# CITY OF CANNON BEACH

## **WATER RESILIENCY PHASE 1 – SEISMIC IMPROVEMENTS**

### **ADDENDUM TO ITB - 2**

# ENGINEERING PLANS - ADDENDUM 2

C002

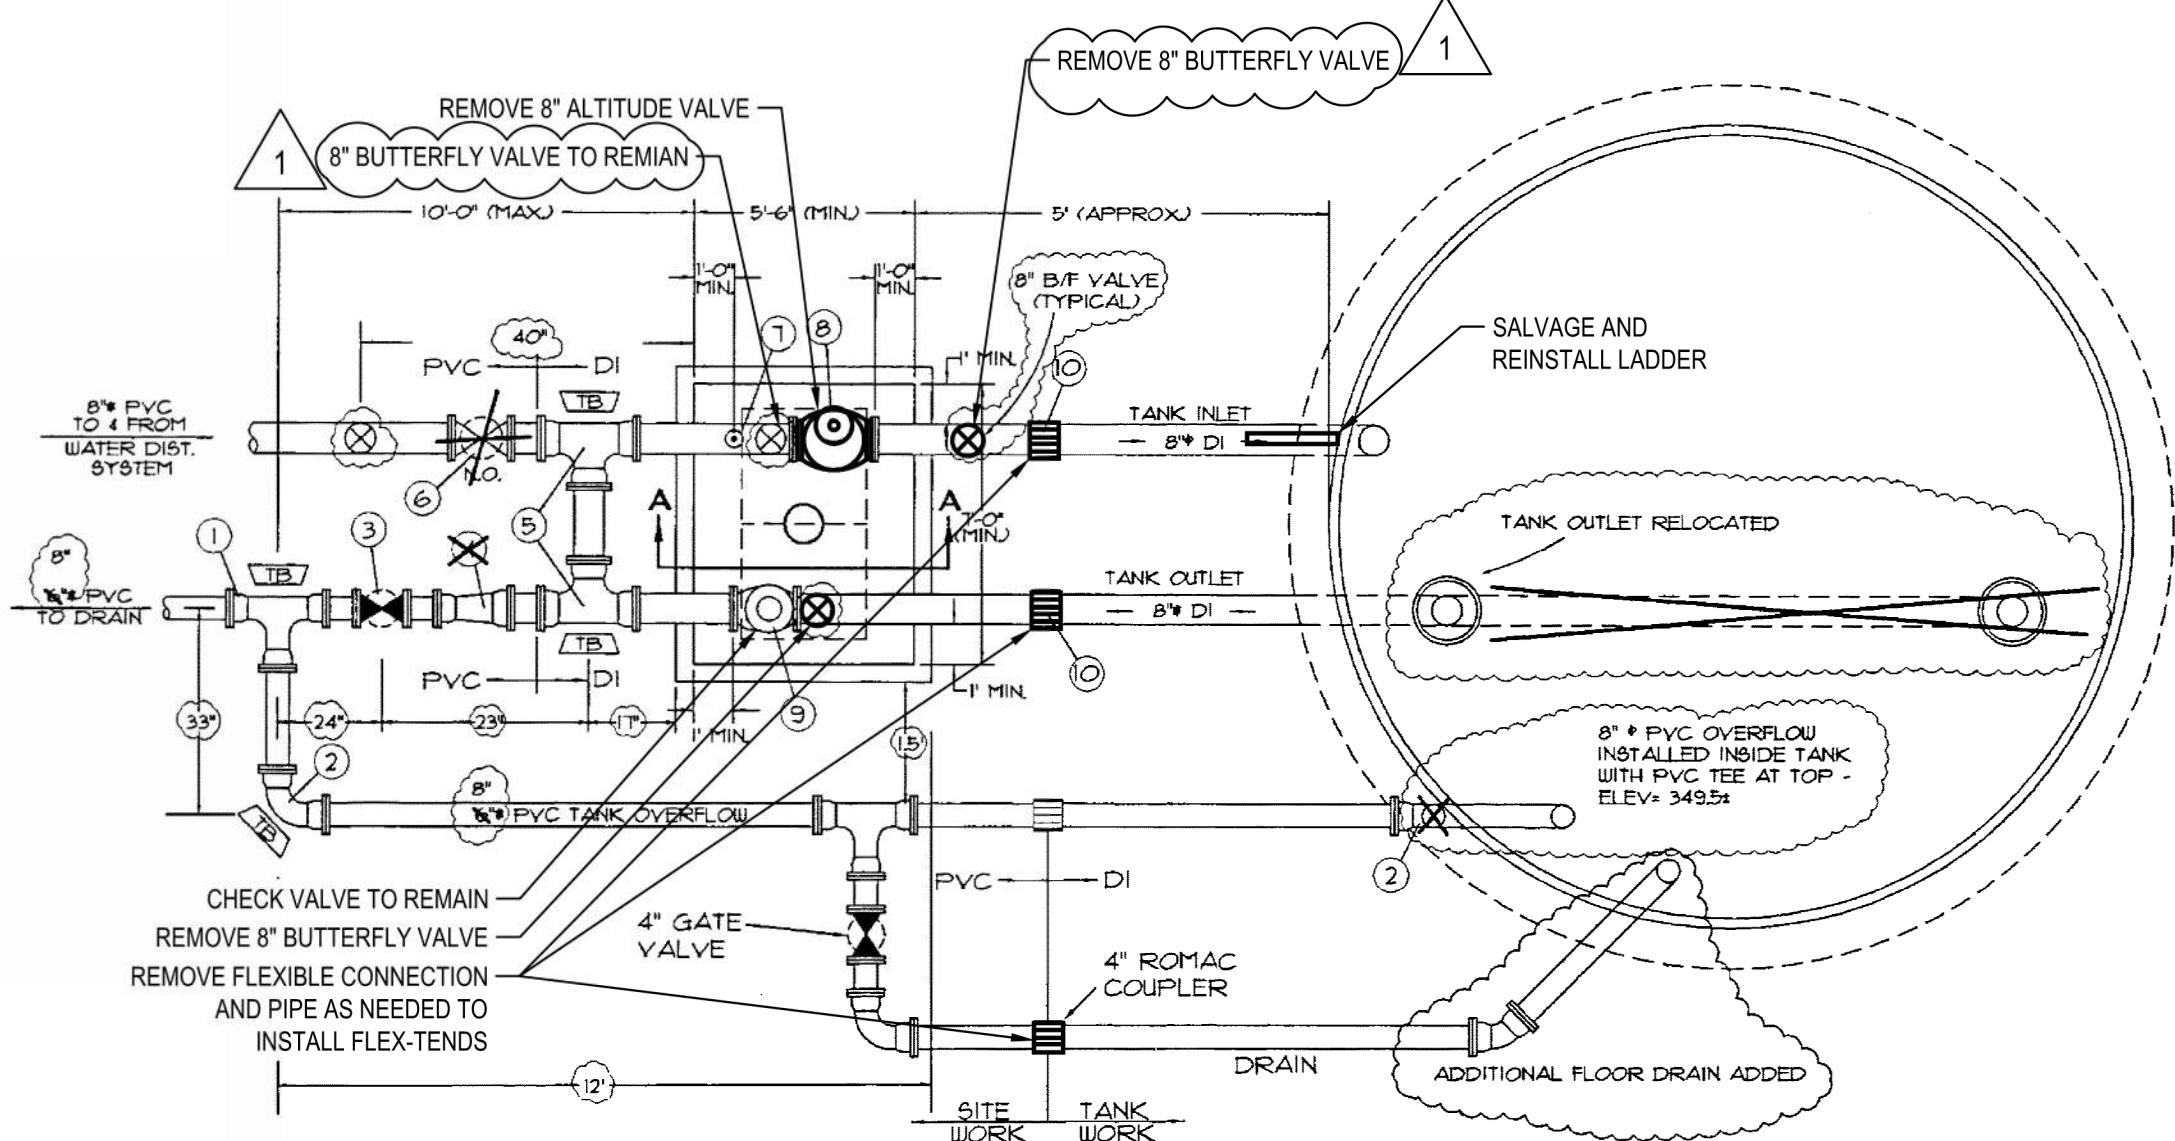
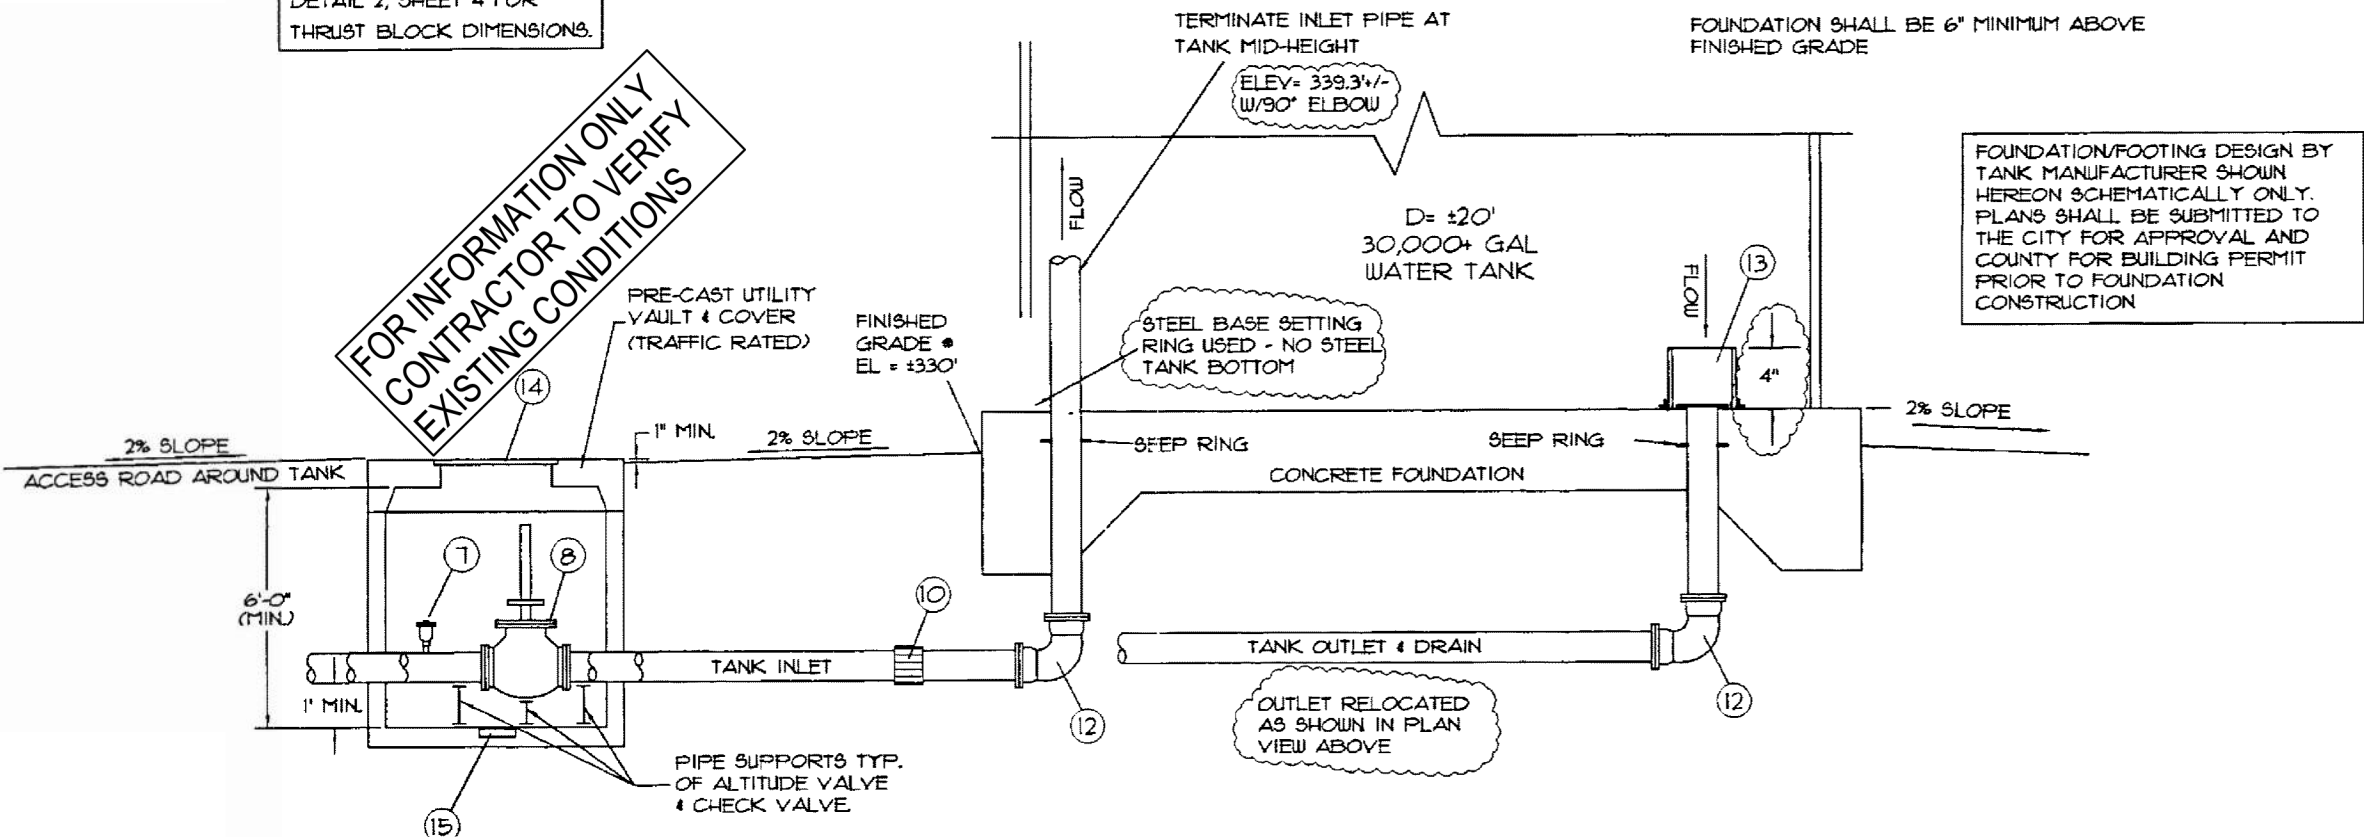
- a. The Butterfly valve in the existing vault on inlet pipe to remain.
  - b. The Butterfly valve between vault and the reservoir on the inlet pipe is to be removed.

C100

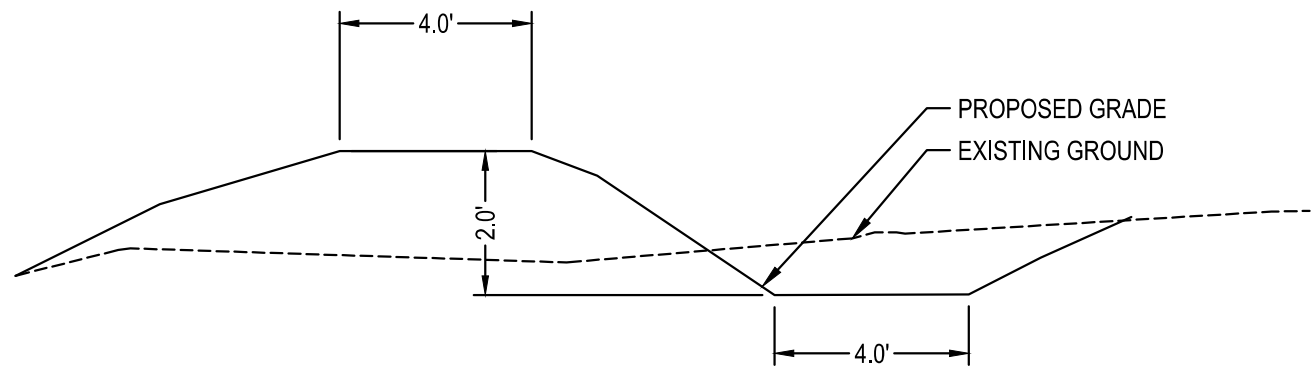
3. Plan Sheet – C100
  - a. Added general note “all construction related signage shall be installed at the city’s public works yard.”
4. Plan Sheet – C102

1. ALL CONSTRUCTION RELATED SIGNAGE SHALL BE POSTED AND AVAILABLE AT THE CITY'S PUBLIC WORKS YARD.

**C102**

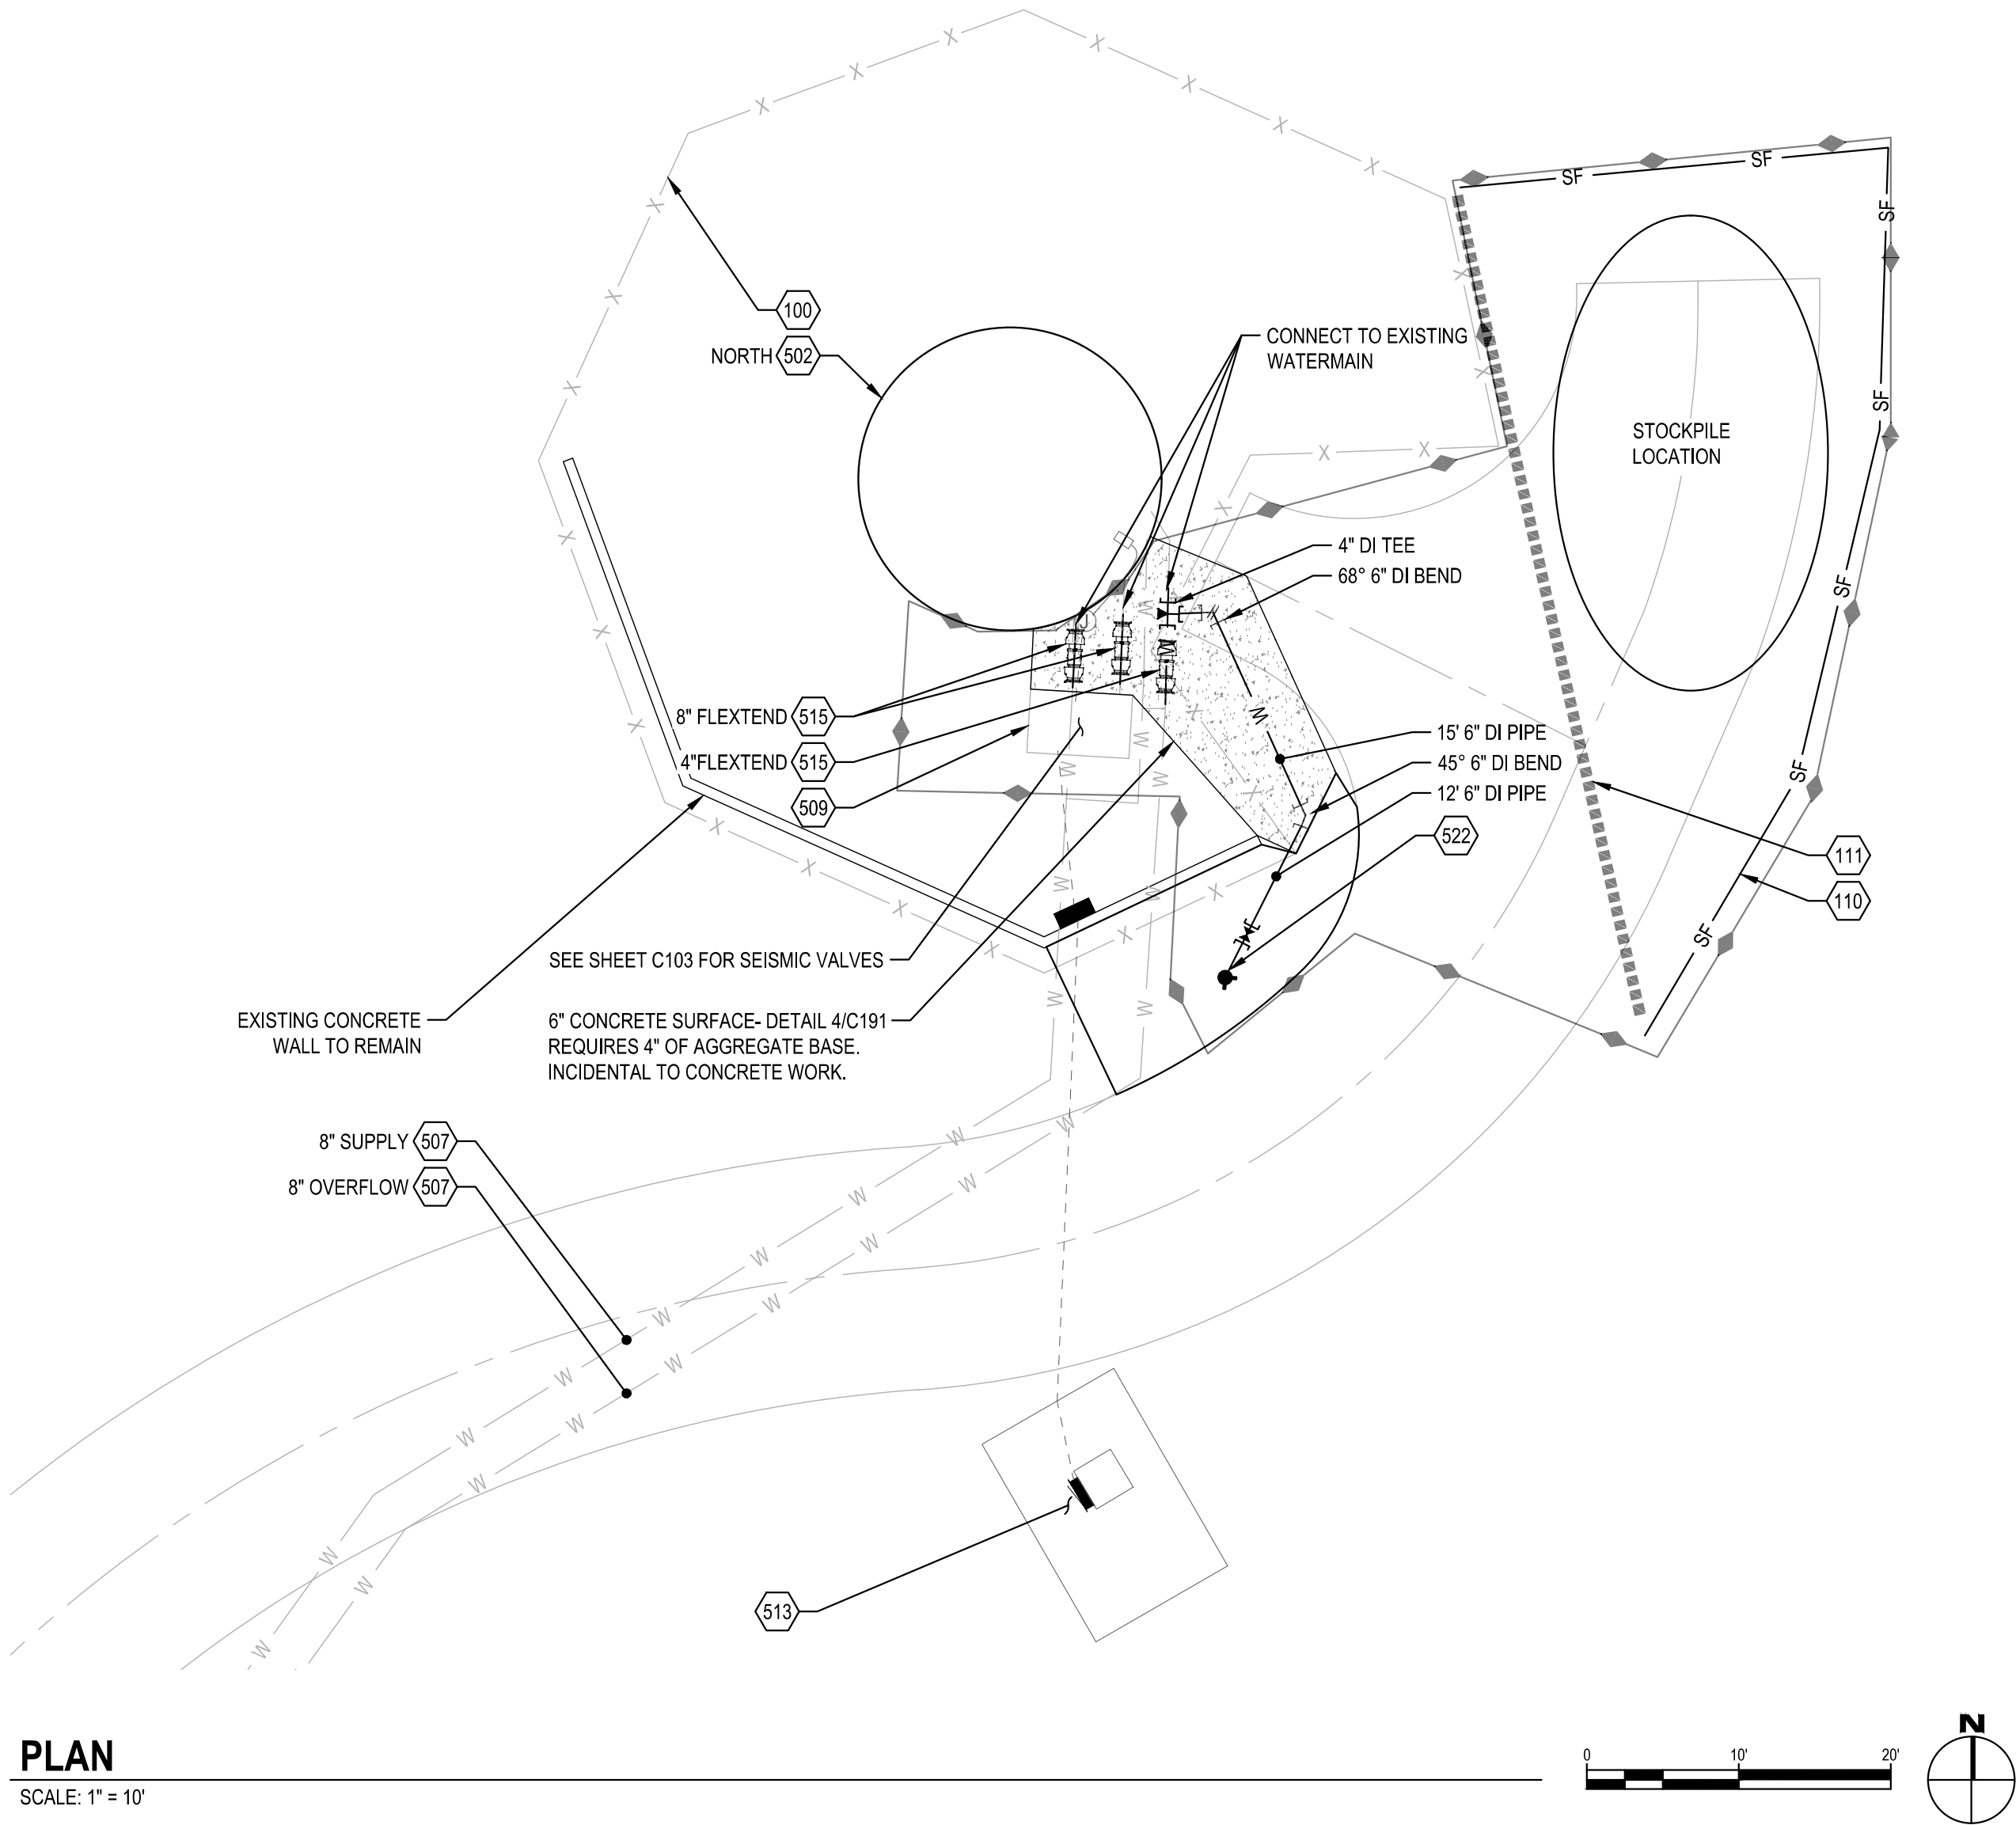
- a. Added general note “all construction related signage shall be installed at the city’s public works yard.”
  - b. Revised north reservoir shutdown note 3 to read “Contractor shall minimize the shutdown to no more than 1 week time period”.

- c. Estimated quantities revised.
    - i. Connect to existing main = 1
    - ii. 8” Check valve = 1
    - iii. 8” Gate valve with actuator = 1
5. Plan Sheet – C103

1. ALL CONSTRUCTION RELATED SIGNAGE SHALL BE POSTED AND AVAILABLE AT THE CITY'S PUBLIC WORKS YARD.
2. CITY, CONTRACTOR, AND ENGINEER TO HAVE A MEETING TO DISCUSS COORDINATION, RESPONSIBILITIES, AND LIMITATIONS RELATED TO WATER SHUTDOWNS.

1. PROVIDE THE CITY ONE WEEK NOTICE BEFORE REQUIRING WATER SHUT DOWN TO PERFORM WORK.
2. CITY WILL BE ABLE TO DRAIN THE NORTH RESERVOIR PRIOR TO CONNECTION WORK. ESTIMATED TIME TO DRAIN TANK IS 30-60 MIN.
3. CONTRACTOR SHALL MINIMIZE THE SHUTDOWN TO NO MORE THEN 1 WEEK TIME PERIOD.
4. THE CITY WILL REFILL THE TANK UPON COMPLETION OF THE WORK PERFORMED DURING THE SHUTDOWN PERIOD.
